STAFF RECOMMENDATION

NCPC File No. 6267

PENTAGON RESERVATION
MEMORIAL TO THE VICTIMS OF SEPTEMBER 11, 2001 (PARK AND GATEWAY)
Arlington County, Virginia

November 30, 2006

Context Projected for Opening Day

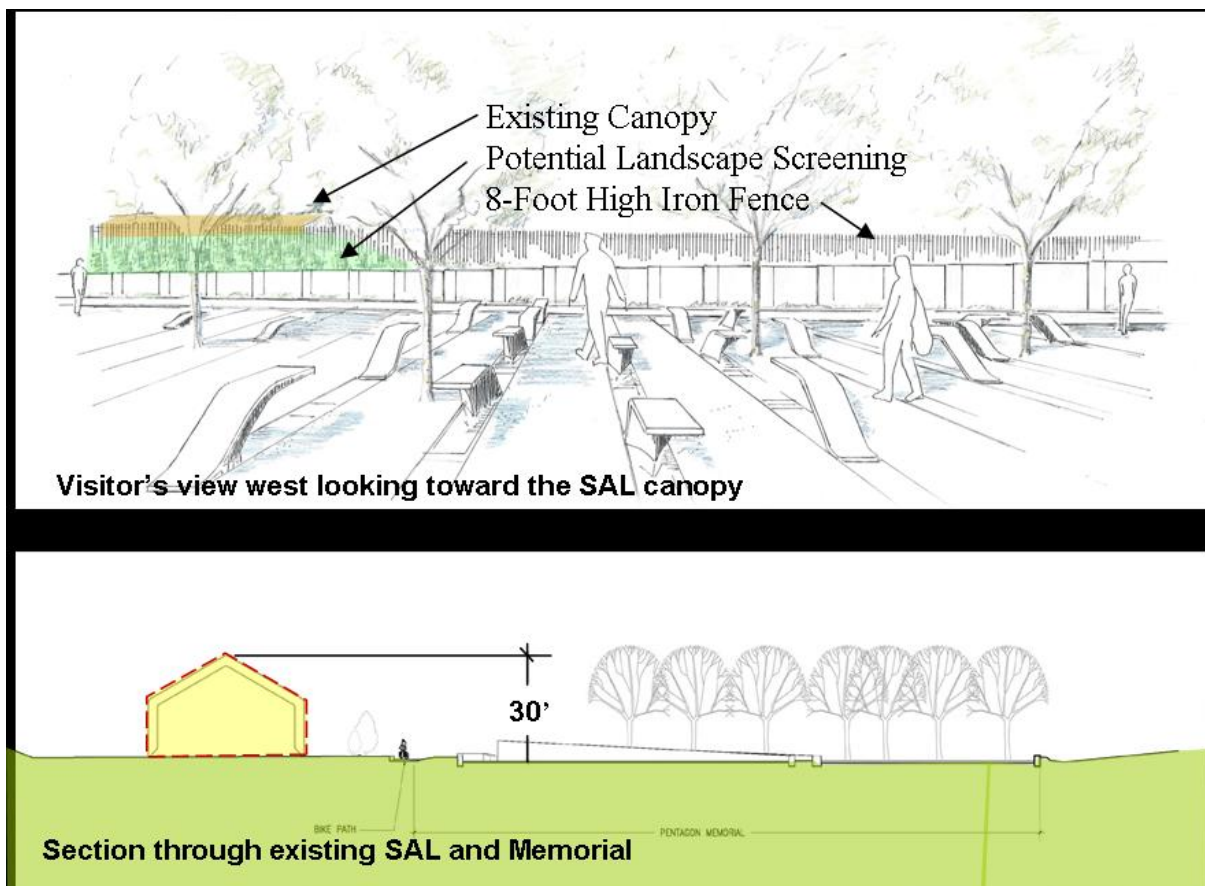
With this submittal, the applicant has included sketches of the memorial, gateway and the SAL for two different timeframes; when the memorial opens, and as envisioned with a future design to replace the temporary canopy at the SAL. Although the sketches convey landscape screening with a broad brush effect rather than with specifics, they help to visualize both potential screening scenarios. A future canopy with a potentially lower roof elevation is effectively screened by a berm that could block a significant portion of its height. Although the Pentagon master planners hope to obtain funds in 2008 to implement the canopy, there is no guarantee, so the specifics of that design have not been fleshed out at this time.

Potential Vision of Future SAL Canopy with Berm

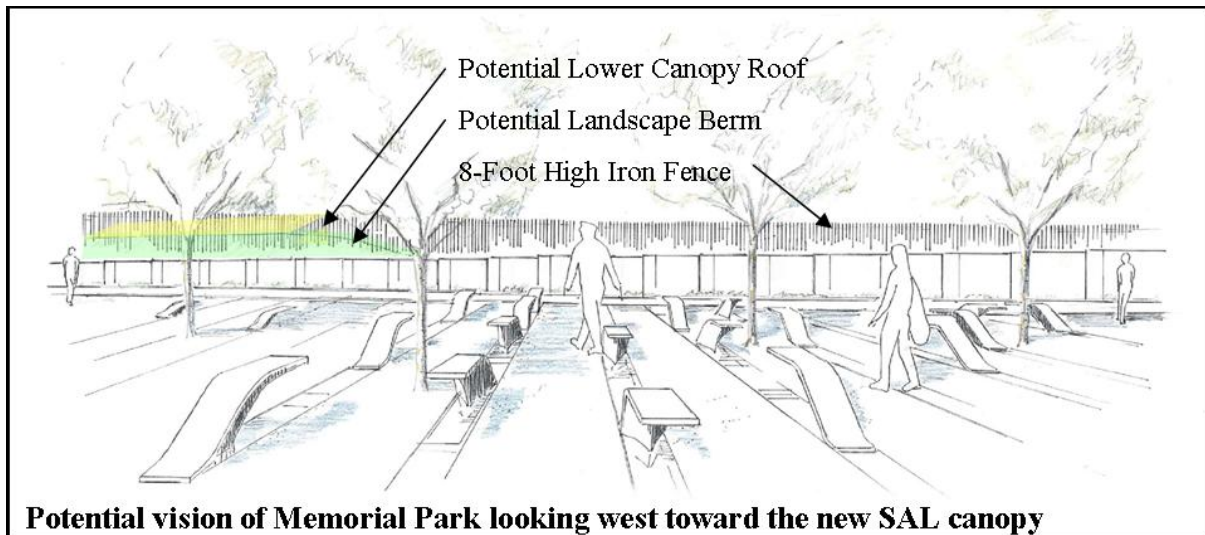
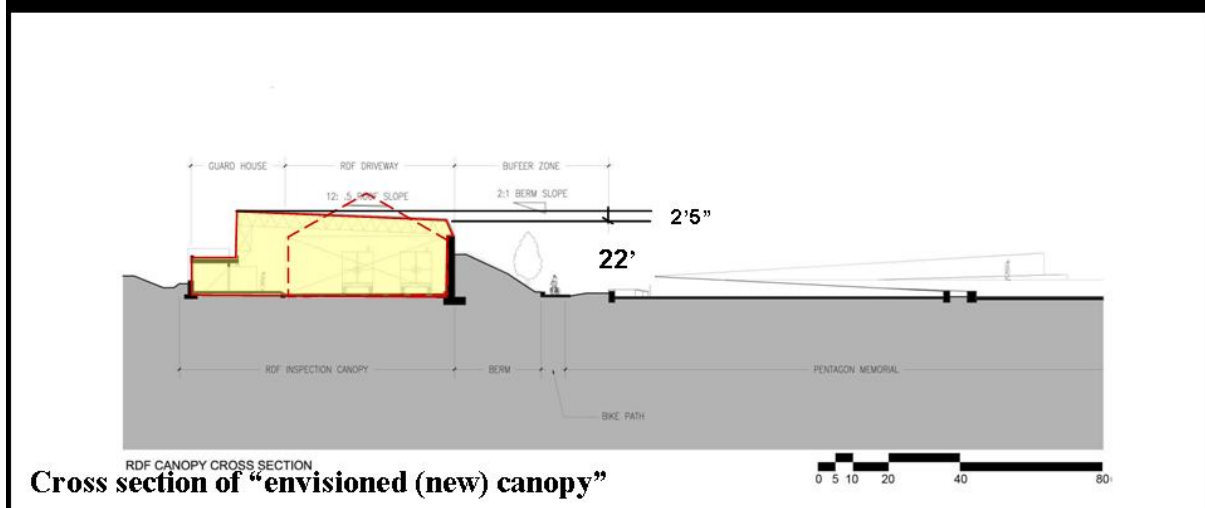
Although the applicant submitted a site plan for when the memorial opens, and not for future parking and bus drop off after the road realignment of North Rotary Road, staff understands that the applicant does not know the specific design of the plan now, but expects that it will follow the master plan and will be submitted for Commission review once designed. In the submittal, the applicant cites the Columbia Pike Transit Initiative, which is expected to alleviate traffic congestion and provide access to the memorial in the future. Under the Initiative, the applicant further cites a WMATA Alternatives Analysis that proposes future implementation of a modified streetcar line along Columbia Pike, supplemented by bus service between the Pentagon and Pentagon City at peak hours. Staff recommends that the applicant further address the Transit Initiative in DoD's upcoming submittal for its Naval Annex Master Plan. Staff reiterates the recommendation that DoD develop an urban design plan for the area between the Pentagon Memorial and the Air Force Memorial across Route 27 with the goal of improving pedestrian and vehicular connections and circulation patterns between the two.

Context Projected for Opening Day

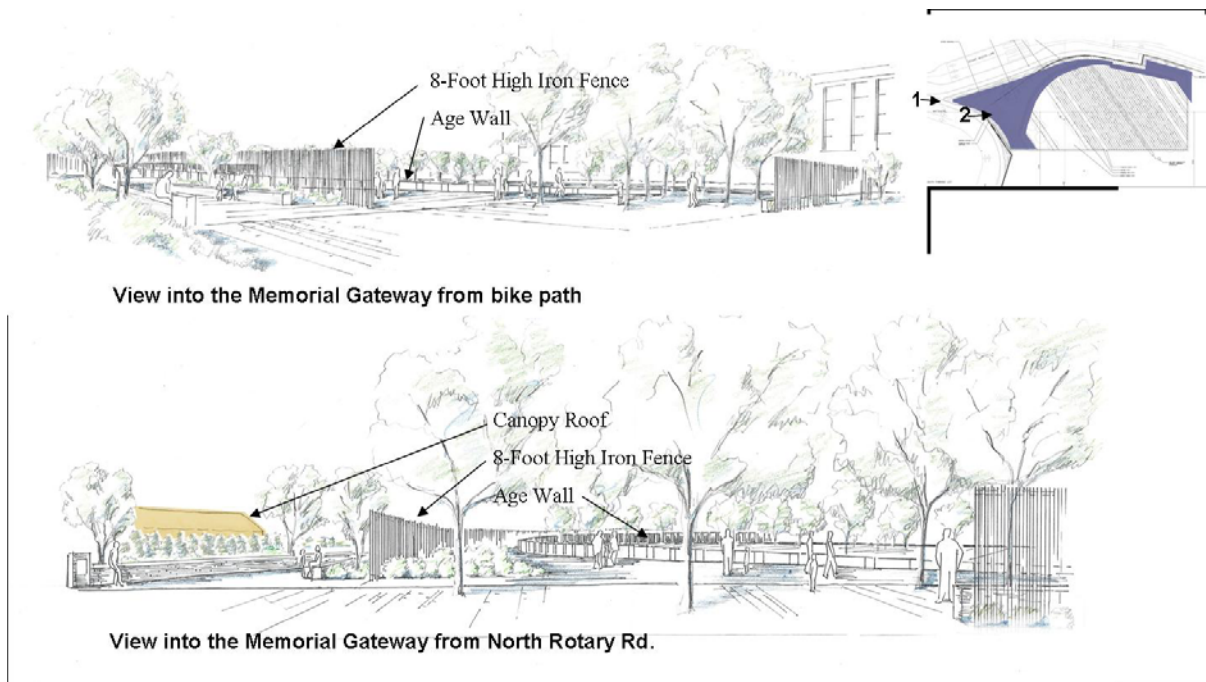
The applicant has submitted a site plan showing the closest visitor parking across Interstate 395 at the Pentagon City Mall Parking garage, in addition to a site plan showing several handicap accessible spaces for visitors and a bus drop off near the Memorial to provide access under the existing roadway scenario when the Memorial opens. However, this site plan indicates so few accessible parking spaces, that staff questions how it was determined. Staff has concerns that the number and location of handicapped parking spaces provided after road realignment could be even less satisfactory, given the distance it will be moved and any growth in visitorship. Staff recommends further study of how many handicapped-accessible spaces will be needed based on projected visitorship, and where they will be provided, after realignment of North Rotary Road and South Parking. Although the applicant did not submit a plan proposing parking and

circulation after the realignment, staff understands that the applicant does not know the specific design of the plan now, but expects that it will follow the master plan vision for a pedestrian plaza. Staff reminds DoD to submit projects for the realignment of the road and the Pedestrian Plaza once developed. Given the families' request to operate 24 hours a day, seven days a week, staff believes that the feasibility of 24-hour operation should be studied further.
